RE: Roll Tide Properties Corp. / Deer Meadows Subdivision Appeal 21-061 AP
(Appeal of File No. 21-014 SUB/TREE)

PROJECT: DEER MEADOWS SUBDIVISION

PRELIMINARY PLAT MAP (REVISED 2-18-22)

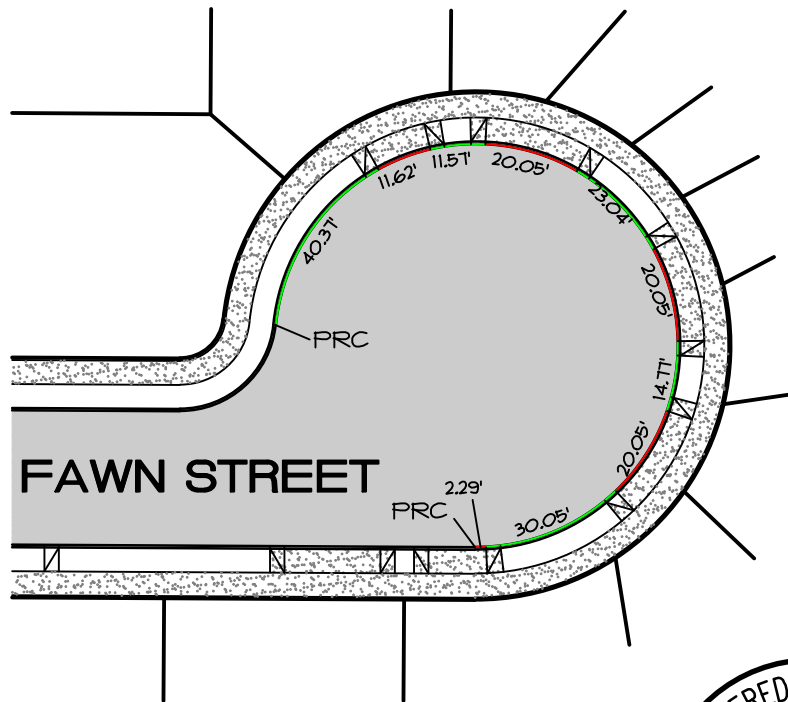
4) The Applicant proposes Lot 12 with less than the minimum 20 feet of street frontage as required by SDC 17.36.30(C).

9) The applicant's proposal does not clearly define if they propose to replace the 8-inch diameter water line and/or install an 18-inch water line in conformance with the Water Master Plan.

11) The proposed 10-foot-wide public storm drainage easements depicted between Lots 27 and 28 and at the rear of Lots 9-13 do not meet the minimum dimensional requirement for public facility easements in Section 17.84.90(A)(2).

RESPONSE: The Applicant has made a slight revision in the Application to ensure that this standard is met, as shown in **Exhibit 1**. Lot 12 now has 20.13 feet of street frontage; this standard is met. Pursuant to ORS 197.522(3), the Council should impose a condition of approval requiring at least 20 feet of street frontage as demonstrated on **Exhibit 1** to this letter.

- The above notwithstanding, **Exhibit 1** demonstrates how the Applicant can construct an 18” water line. Pursuant to ORS 197.522(3), the Applicant can satisfy this standard with the following condition of approval:

RESPONSE: As demonstrated on **Exhibit 1**, the Applicant now proposes an increase in the 10-foot wide easement to 15 feet wide. Pursuant to ORS 197.522(3), the Applicant can satisfy this requirement by accepting the following condition of approval:

DEER MEADOWS CUL-DE-SAC EXHIBIT

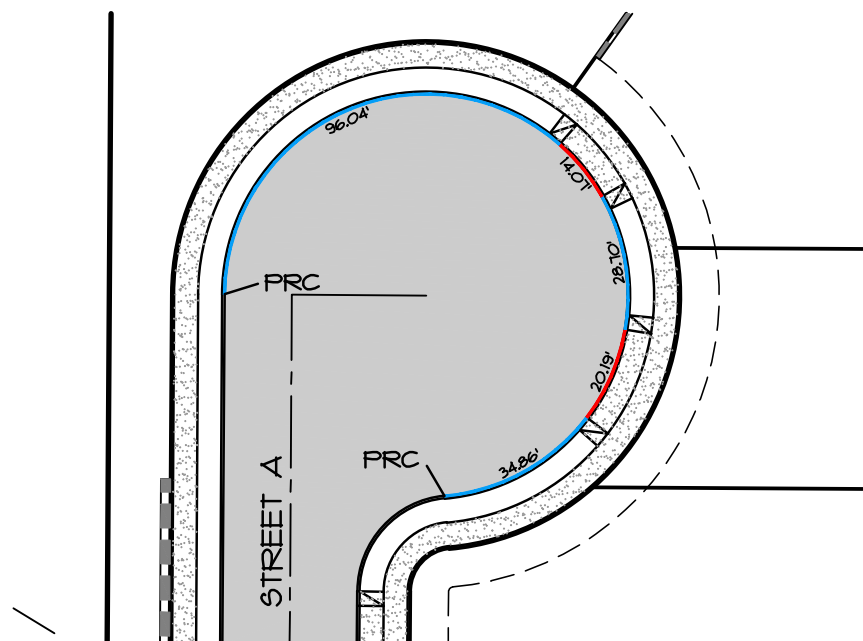
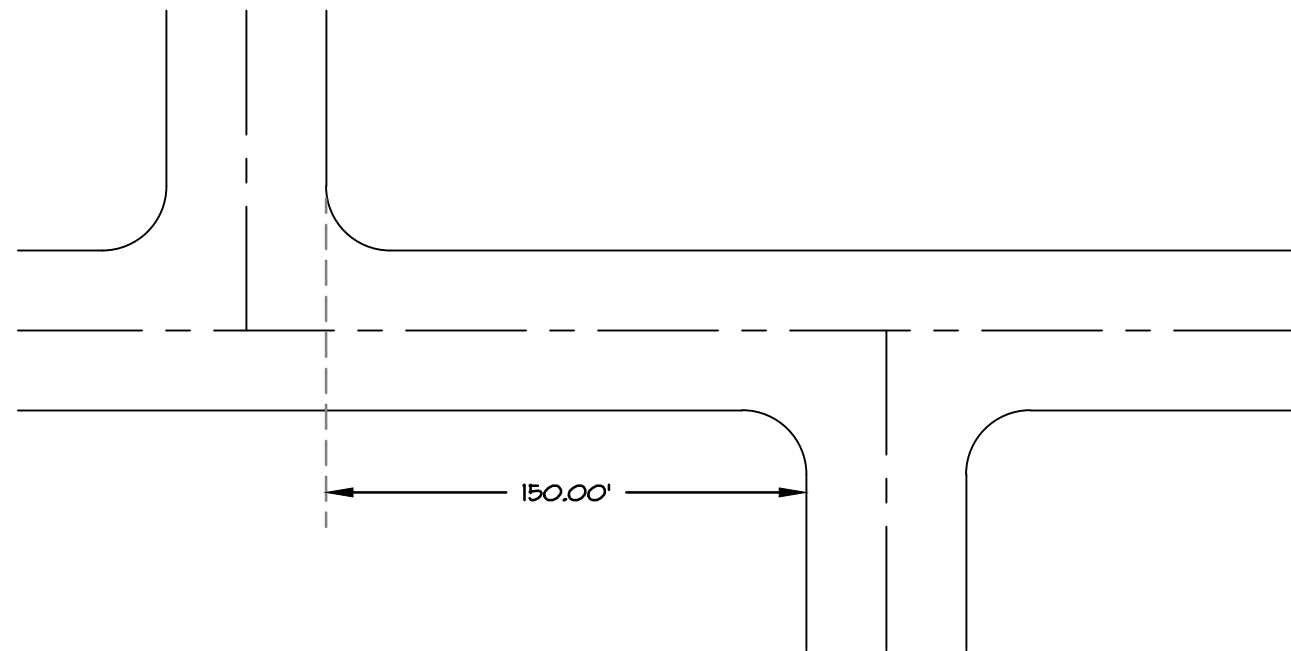
2) The applicant’s statement indicating that “Both of the proposed cul-de-sacs have less than 50% of their circumference covered by driveway drops” is not sufficient as there were no dimensional specifications submitted by the applicant to support this statement.

RESPONSE: **Exhibit 2** provides driveway width information for the Fawn Street and Street A cul-de-sacs. This exhibit demonstrates that the sum of the driveway widths for each cul-de-sac is less than 50%. SDC 17.98.100.F is satisfied.

TOTAL CIRCUMFERENCE FROM PRC TO PRC = 193.85'
 TOTAL GAPS = 119.79' (61.80%)
 TOTAL DRIVEWAY LENGTH = 74.06' (38.20%)
 (38.20% IS LESS THAN 50%. MEETS CODE)

TOTAL CIRCUMFERENCE FROM PRC TO PRC = 193.86'
 TOTAL GAPS = 159.60' (82.3%)
 TOTAL DRIVEWAY LENGTH = 34.26' (17.7%)
 (17.7% IS LESS THAN 50%. MEETS CODE)

DEER MEADOW T-INTERSECTION EXHIBIT

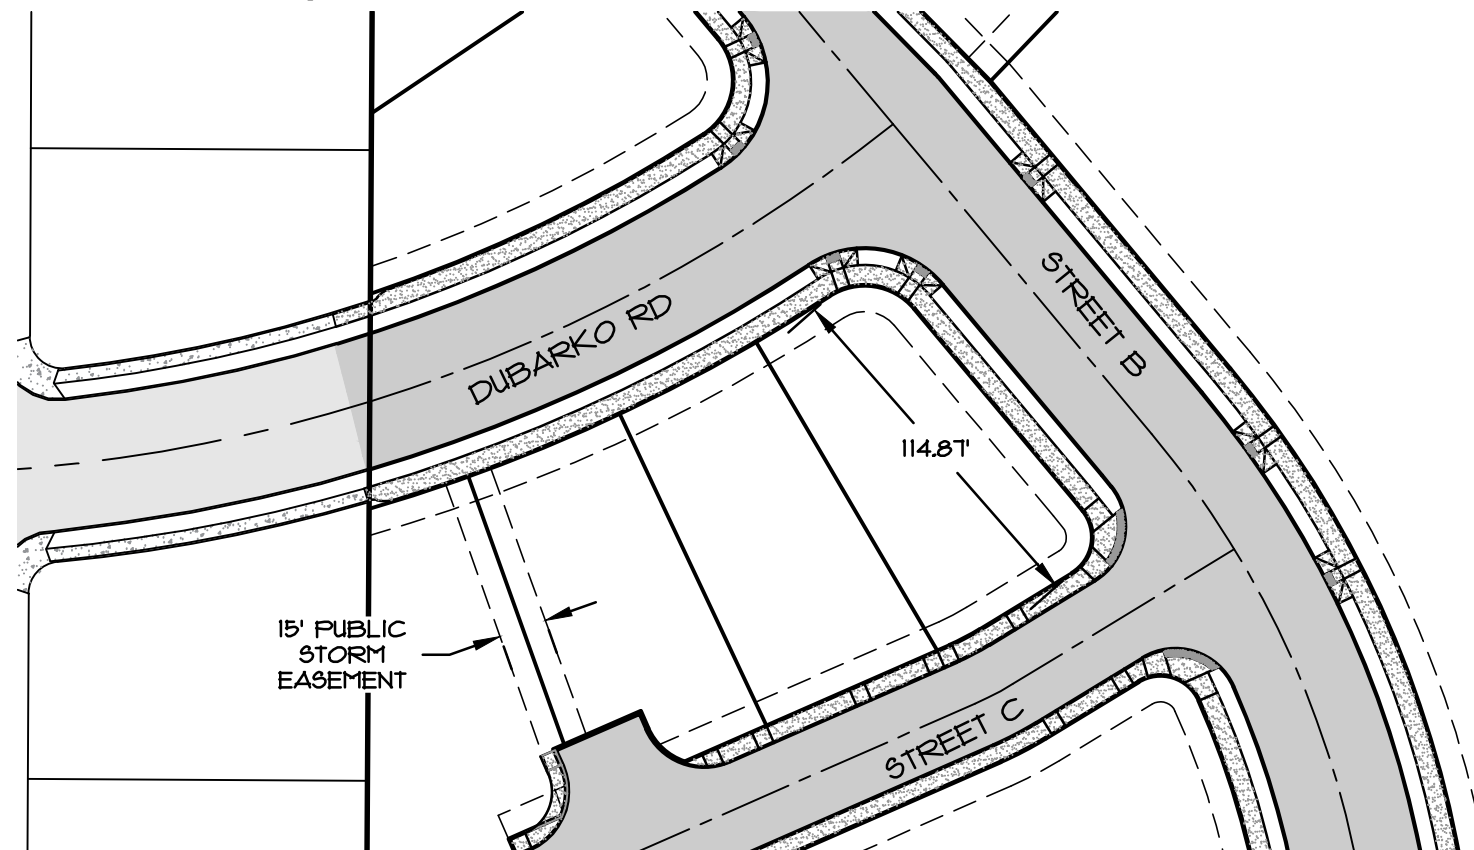
5) The distance between the two nearest edges of the right-of-way between Dubarko Road (an arterial) and Street C (a local street) is less than the minimum 150 ft. dimension in Sections 17.84.50(E)(2) and 17.84.50(J)(3).

This standard does not apply because there is no “staggered street alignment resulting in a ‘T’ intersection. First, there is no street intersection within 150 feet of the proposed termination of Dubarko Road; only a “public access lane.” Second, there are no proposed “staggered” intersections, as demonstrated in **Exhibit 3**.

EXAMPLE OF STAGGERED T-INTERSECTION

PROPOSED T-INTERSECTION (NOT A STAGGERED T-INTERSECTION)

DUBARKO RD WITH 100' TANGENT EXHIBIT

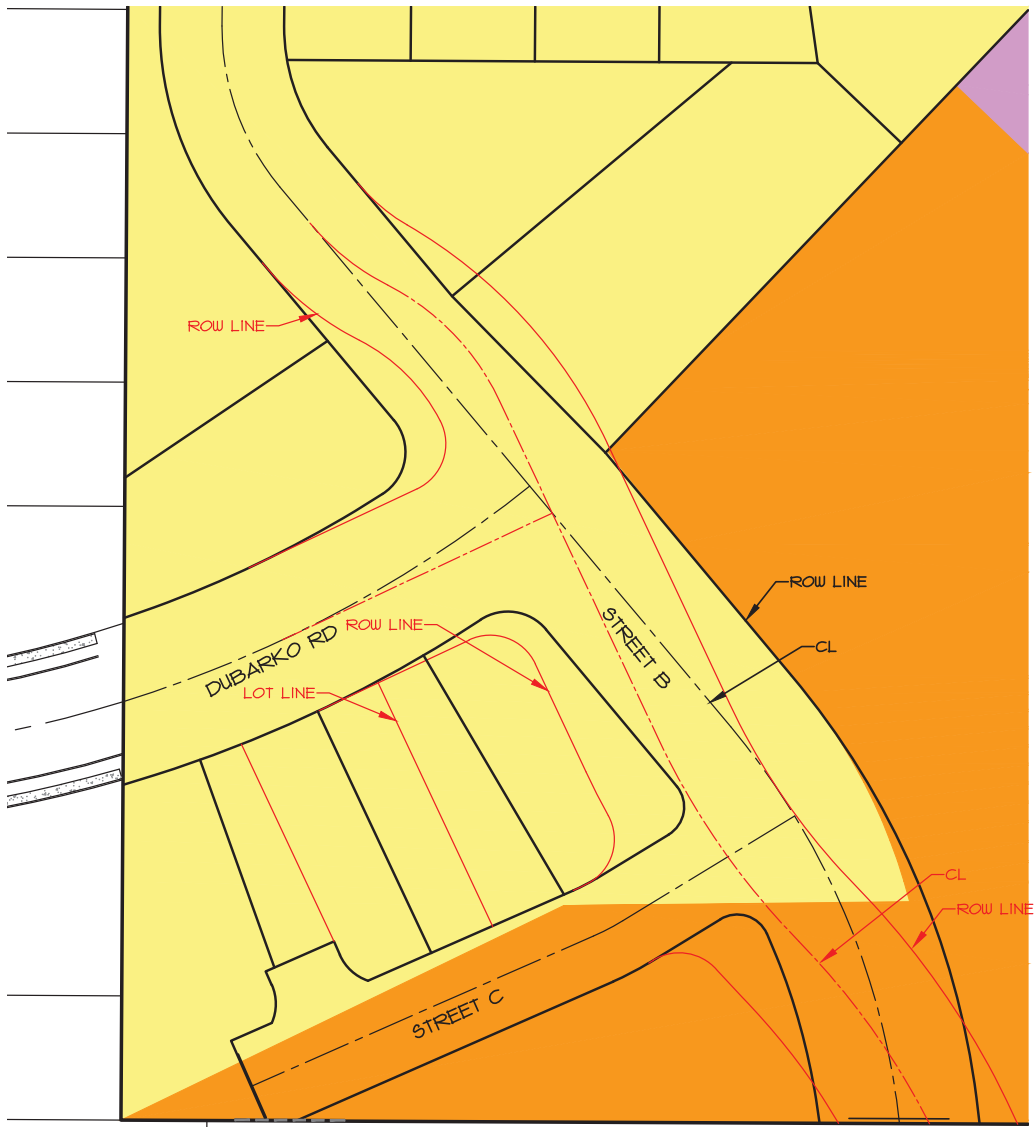
6) The minimum 100 feet of tangent alignment required in Section 17.84.50(J)5(a) is not provided at the intersection of Street “B” (a collector) and Dubarko Road (an arterial) or at the intersection of Dubarko Road and Street “B”.

“The intersection of Street B and Dubarko Road shall have a minimum of 100 feet of straight (tangent) alignment perpendicular to the intersection.”

It is feasible for the Applicant to satisfy this condition as demonstrated on **Exhibit 4**. Under ORS 197.522(3), the Council is required to impose this condition in lieu of denial because it would ensure satisfaction of SDC 17.84.950.J.5.a.

NOTE: 100' TANGENTS CAN BE PROVIDED ON STREET B AND DUBARKO AS SHOWN. THE RESULTING ALIGNMENT WOULD MAKE LOT 32 LARGER, AND ELIMINATE ONE LOT FROM LOTS 21-30.

DEER MEADOWS SUBDIVISION
 REVISED PLAT WITH
 PARKLAND DEDICATION

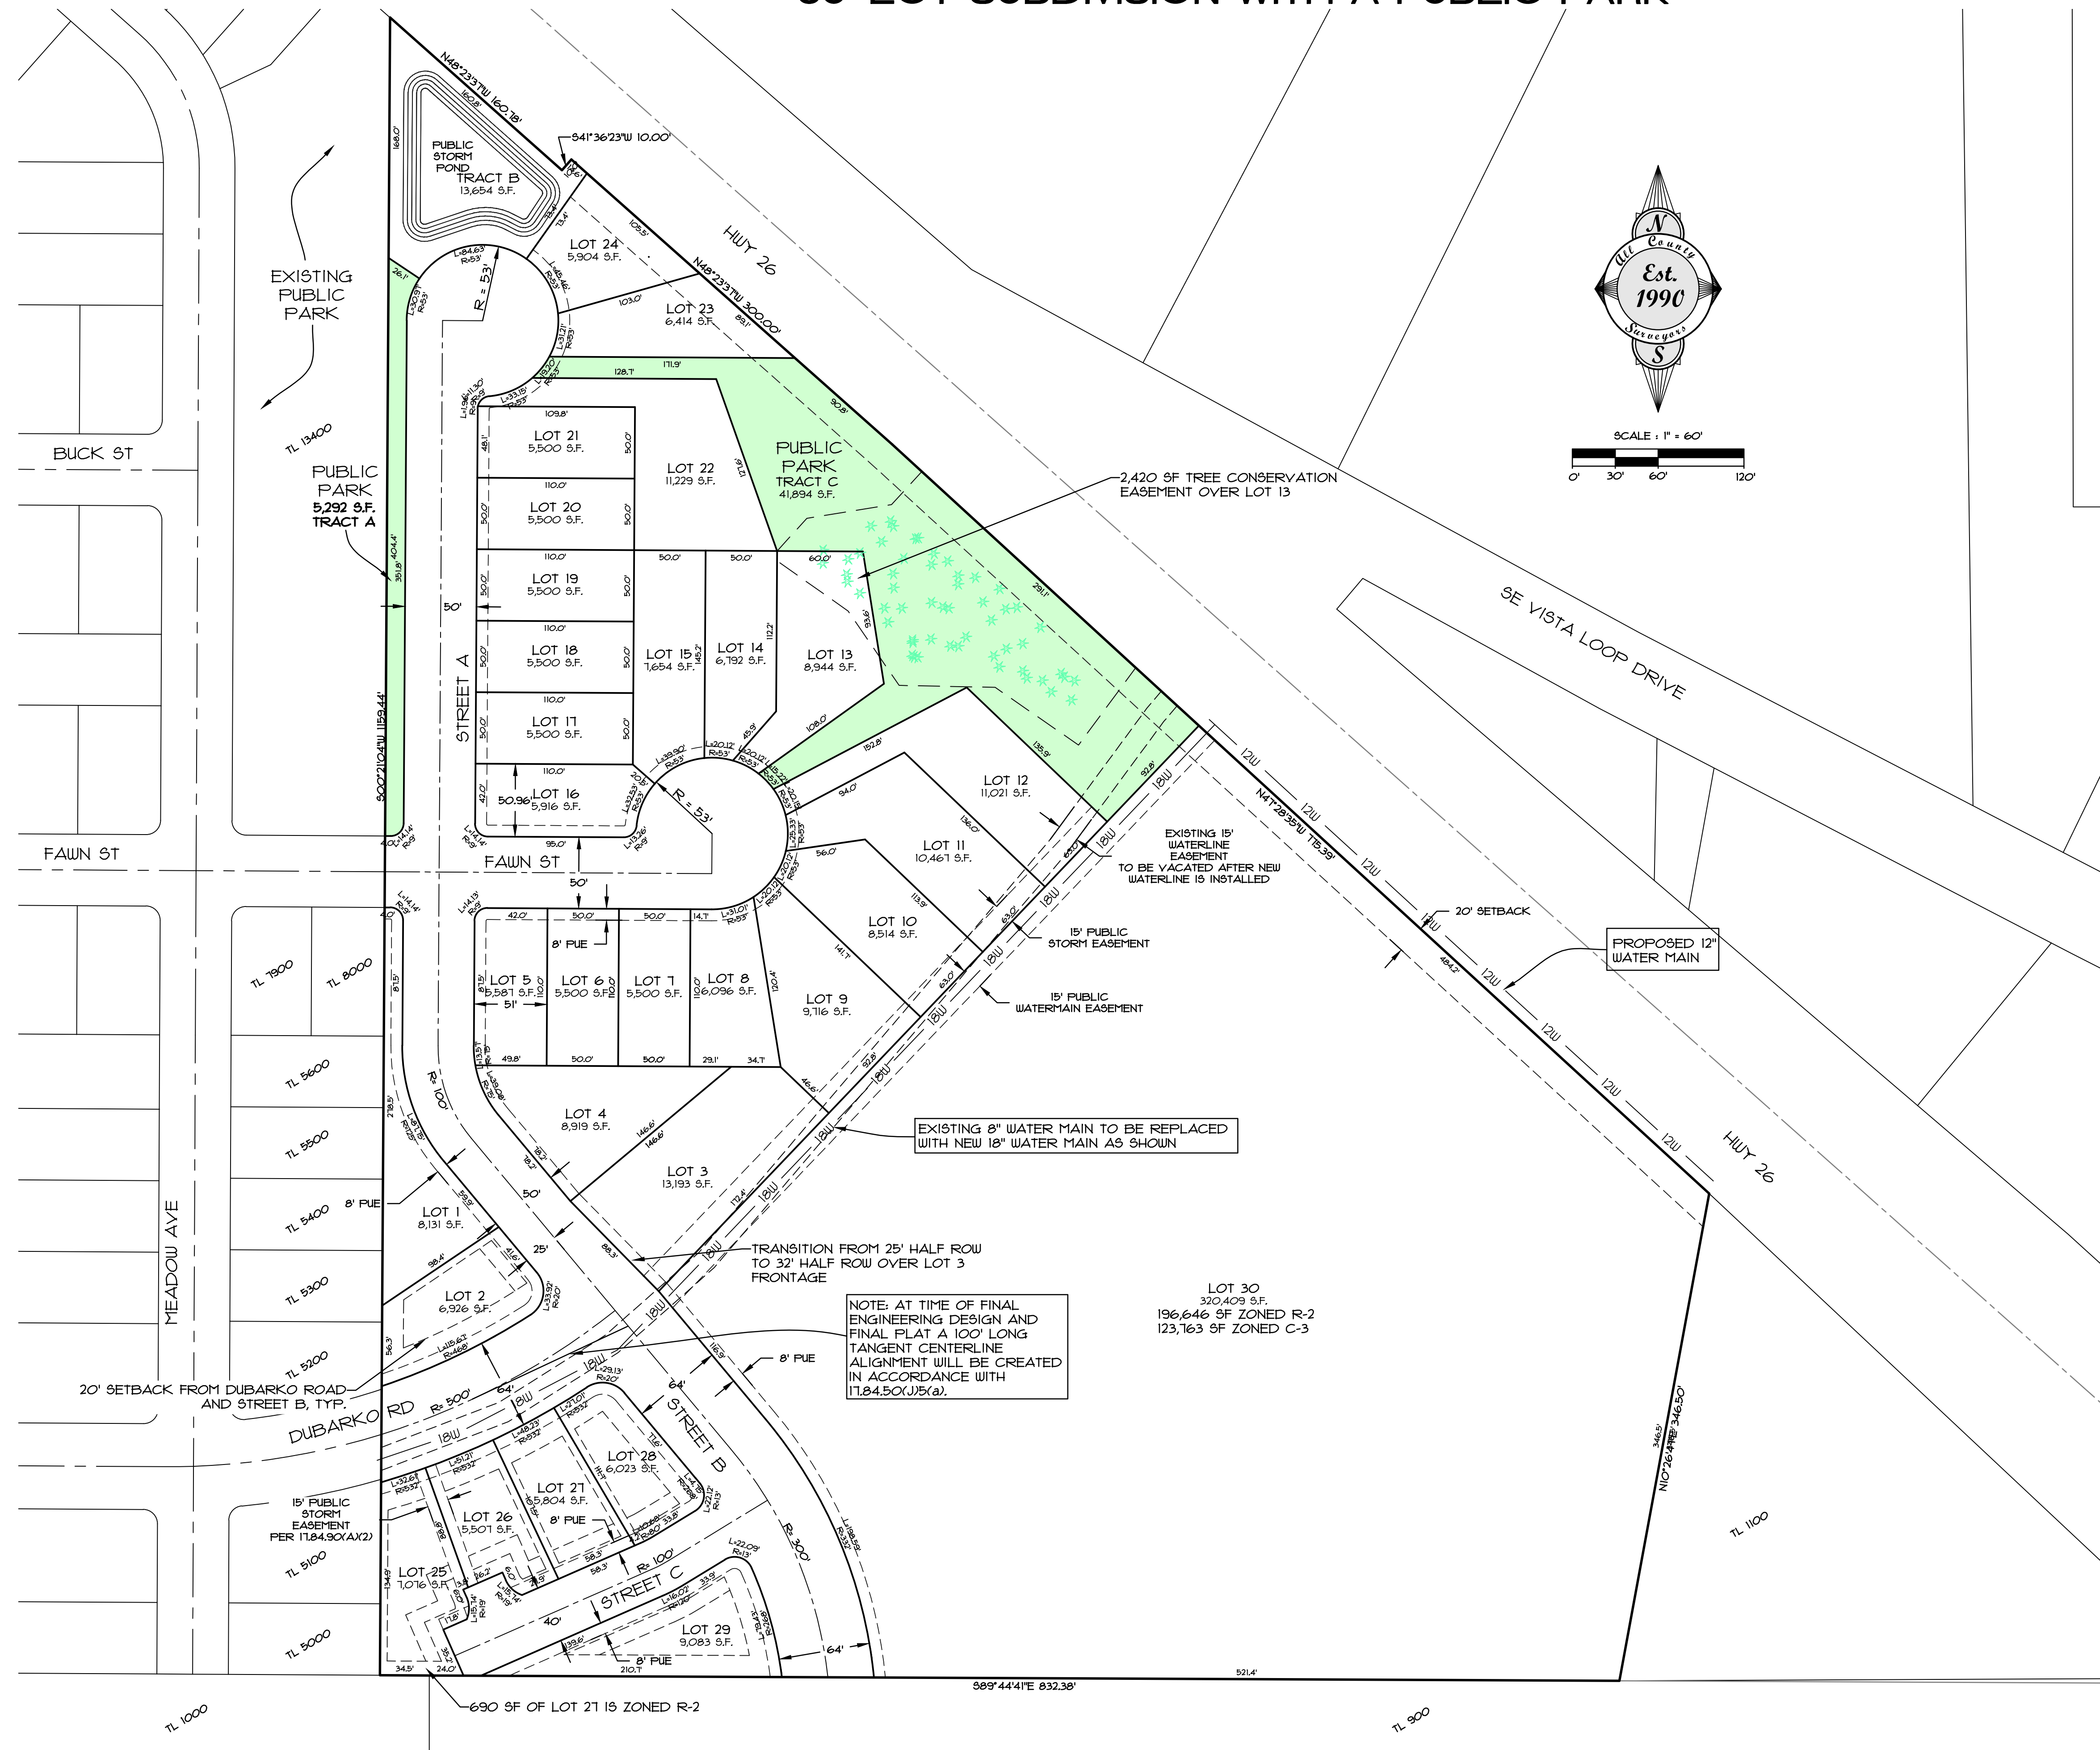
12) This subdivision proposal does not propose to dedicate 0.96 acres of parkland as required by Chapter 17.86. The additional .96 acres could expand Deer Pointe Park consistent with the Parks and Trails Master Plan that was adopted in 1997.

Regardless, **Exhibit 5** demonstrates how the Applicant could provide the minimum required park area. Pursuant to ORS 197.522(3), if the Council nonetheless concludes that it is not barred from requiring the park dedication, it can impose a condition of approval requiring a park area as shown on Exhibit 5 of this letter.

PARKLAND DEDICATION SHOWN AT 4/-1 ACRE. MINIMUM REQUIRED AT TIME OF FINAL PLAT TO BE 0.93 ACRES (40,511 SF). ADJUSTMENTS TO LOT LINES WILL BE MADE AT TIME OF FINAL PLAT TO PROVIDE 0.93 ACRES OR MORE.
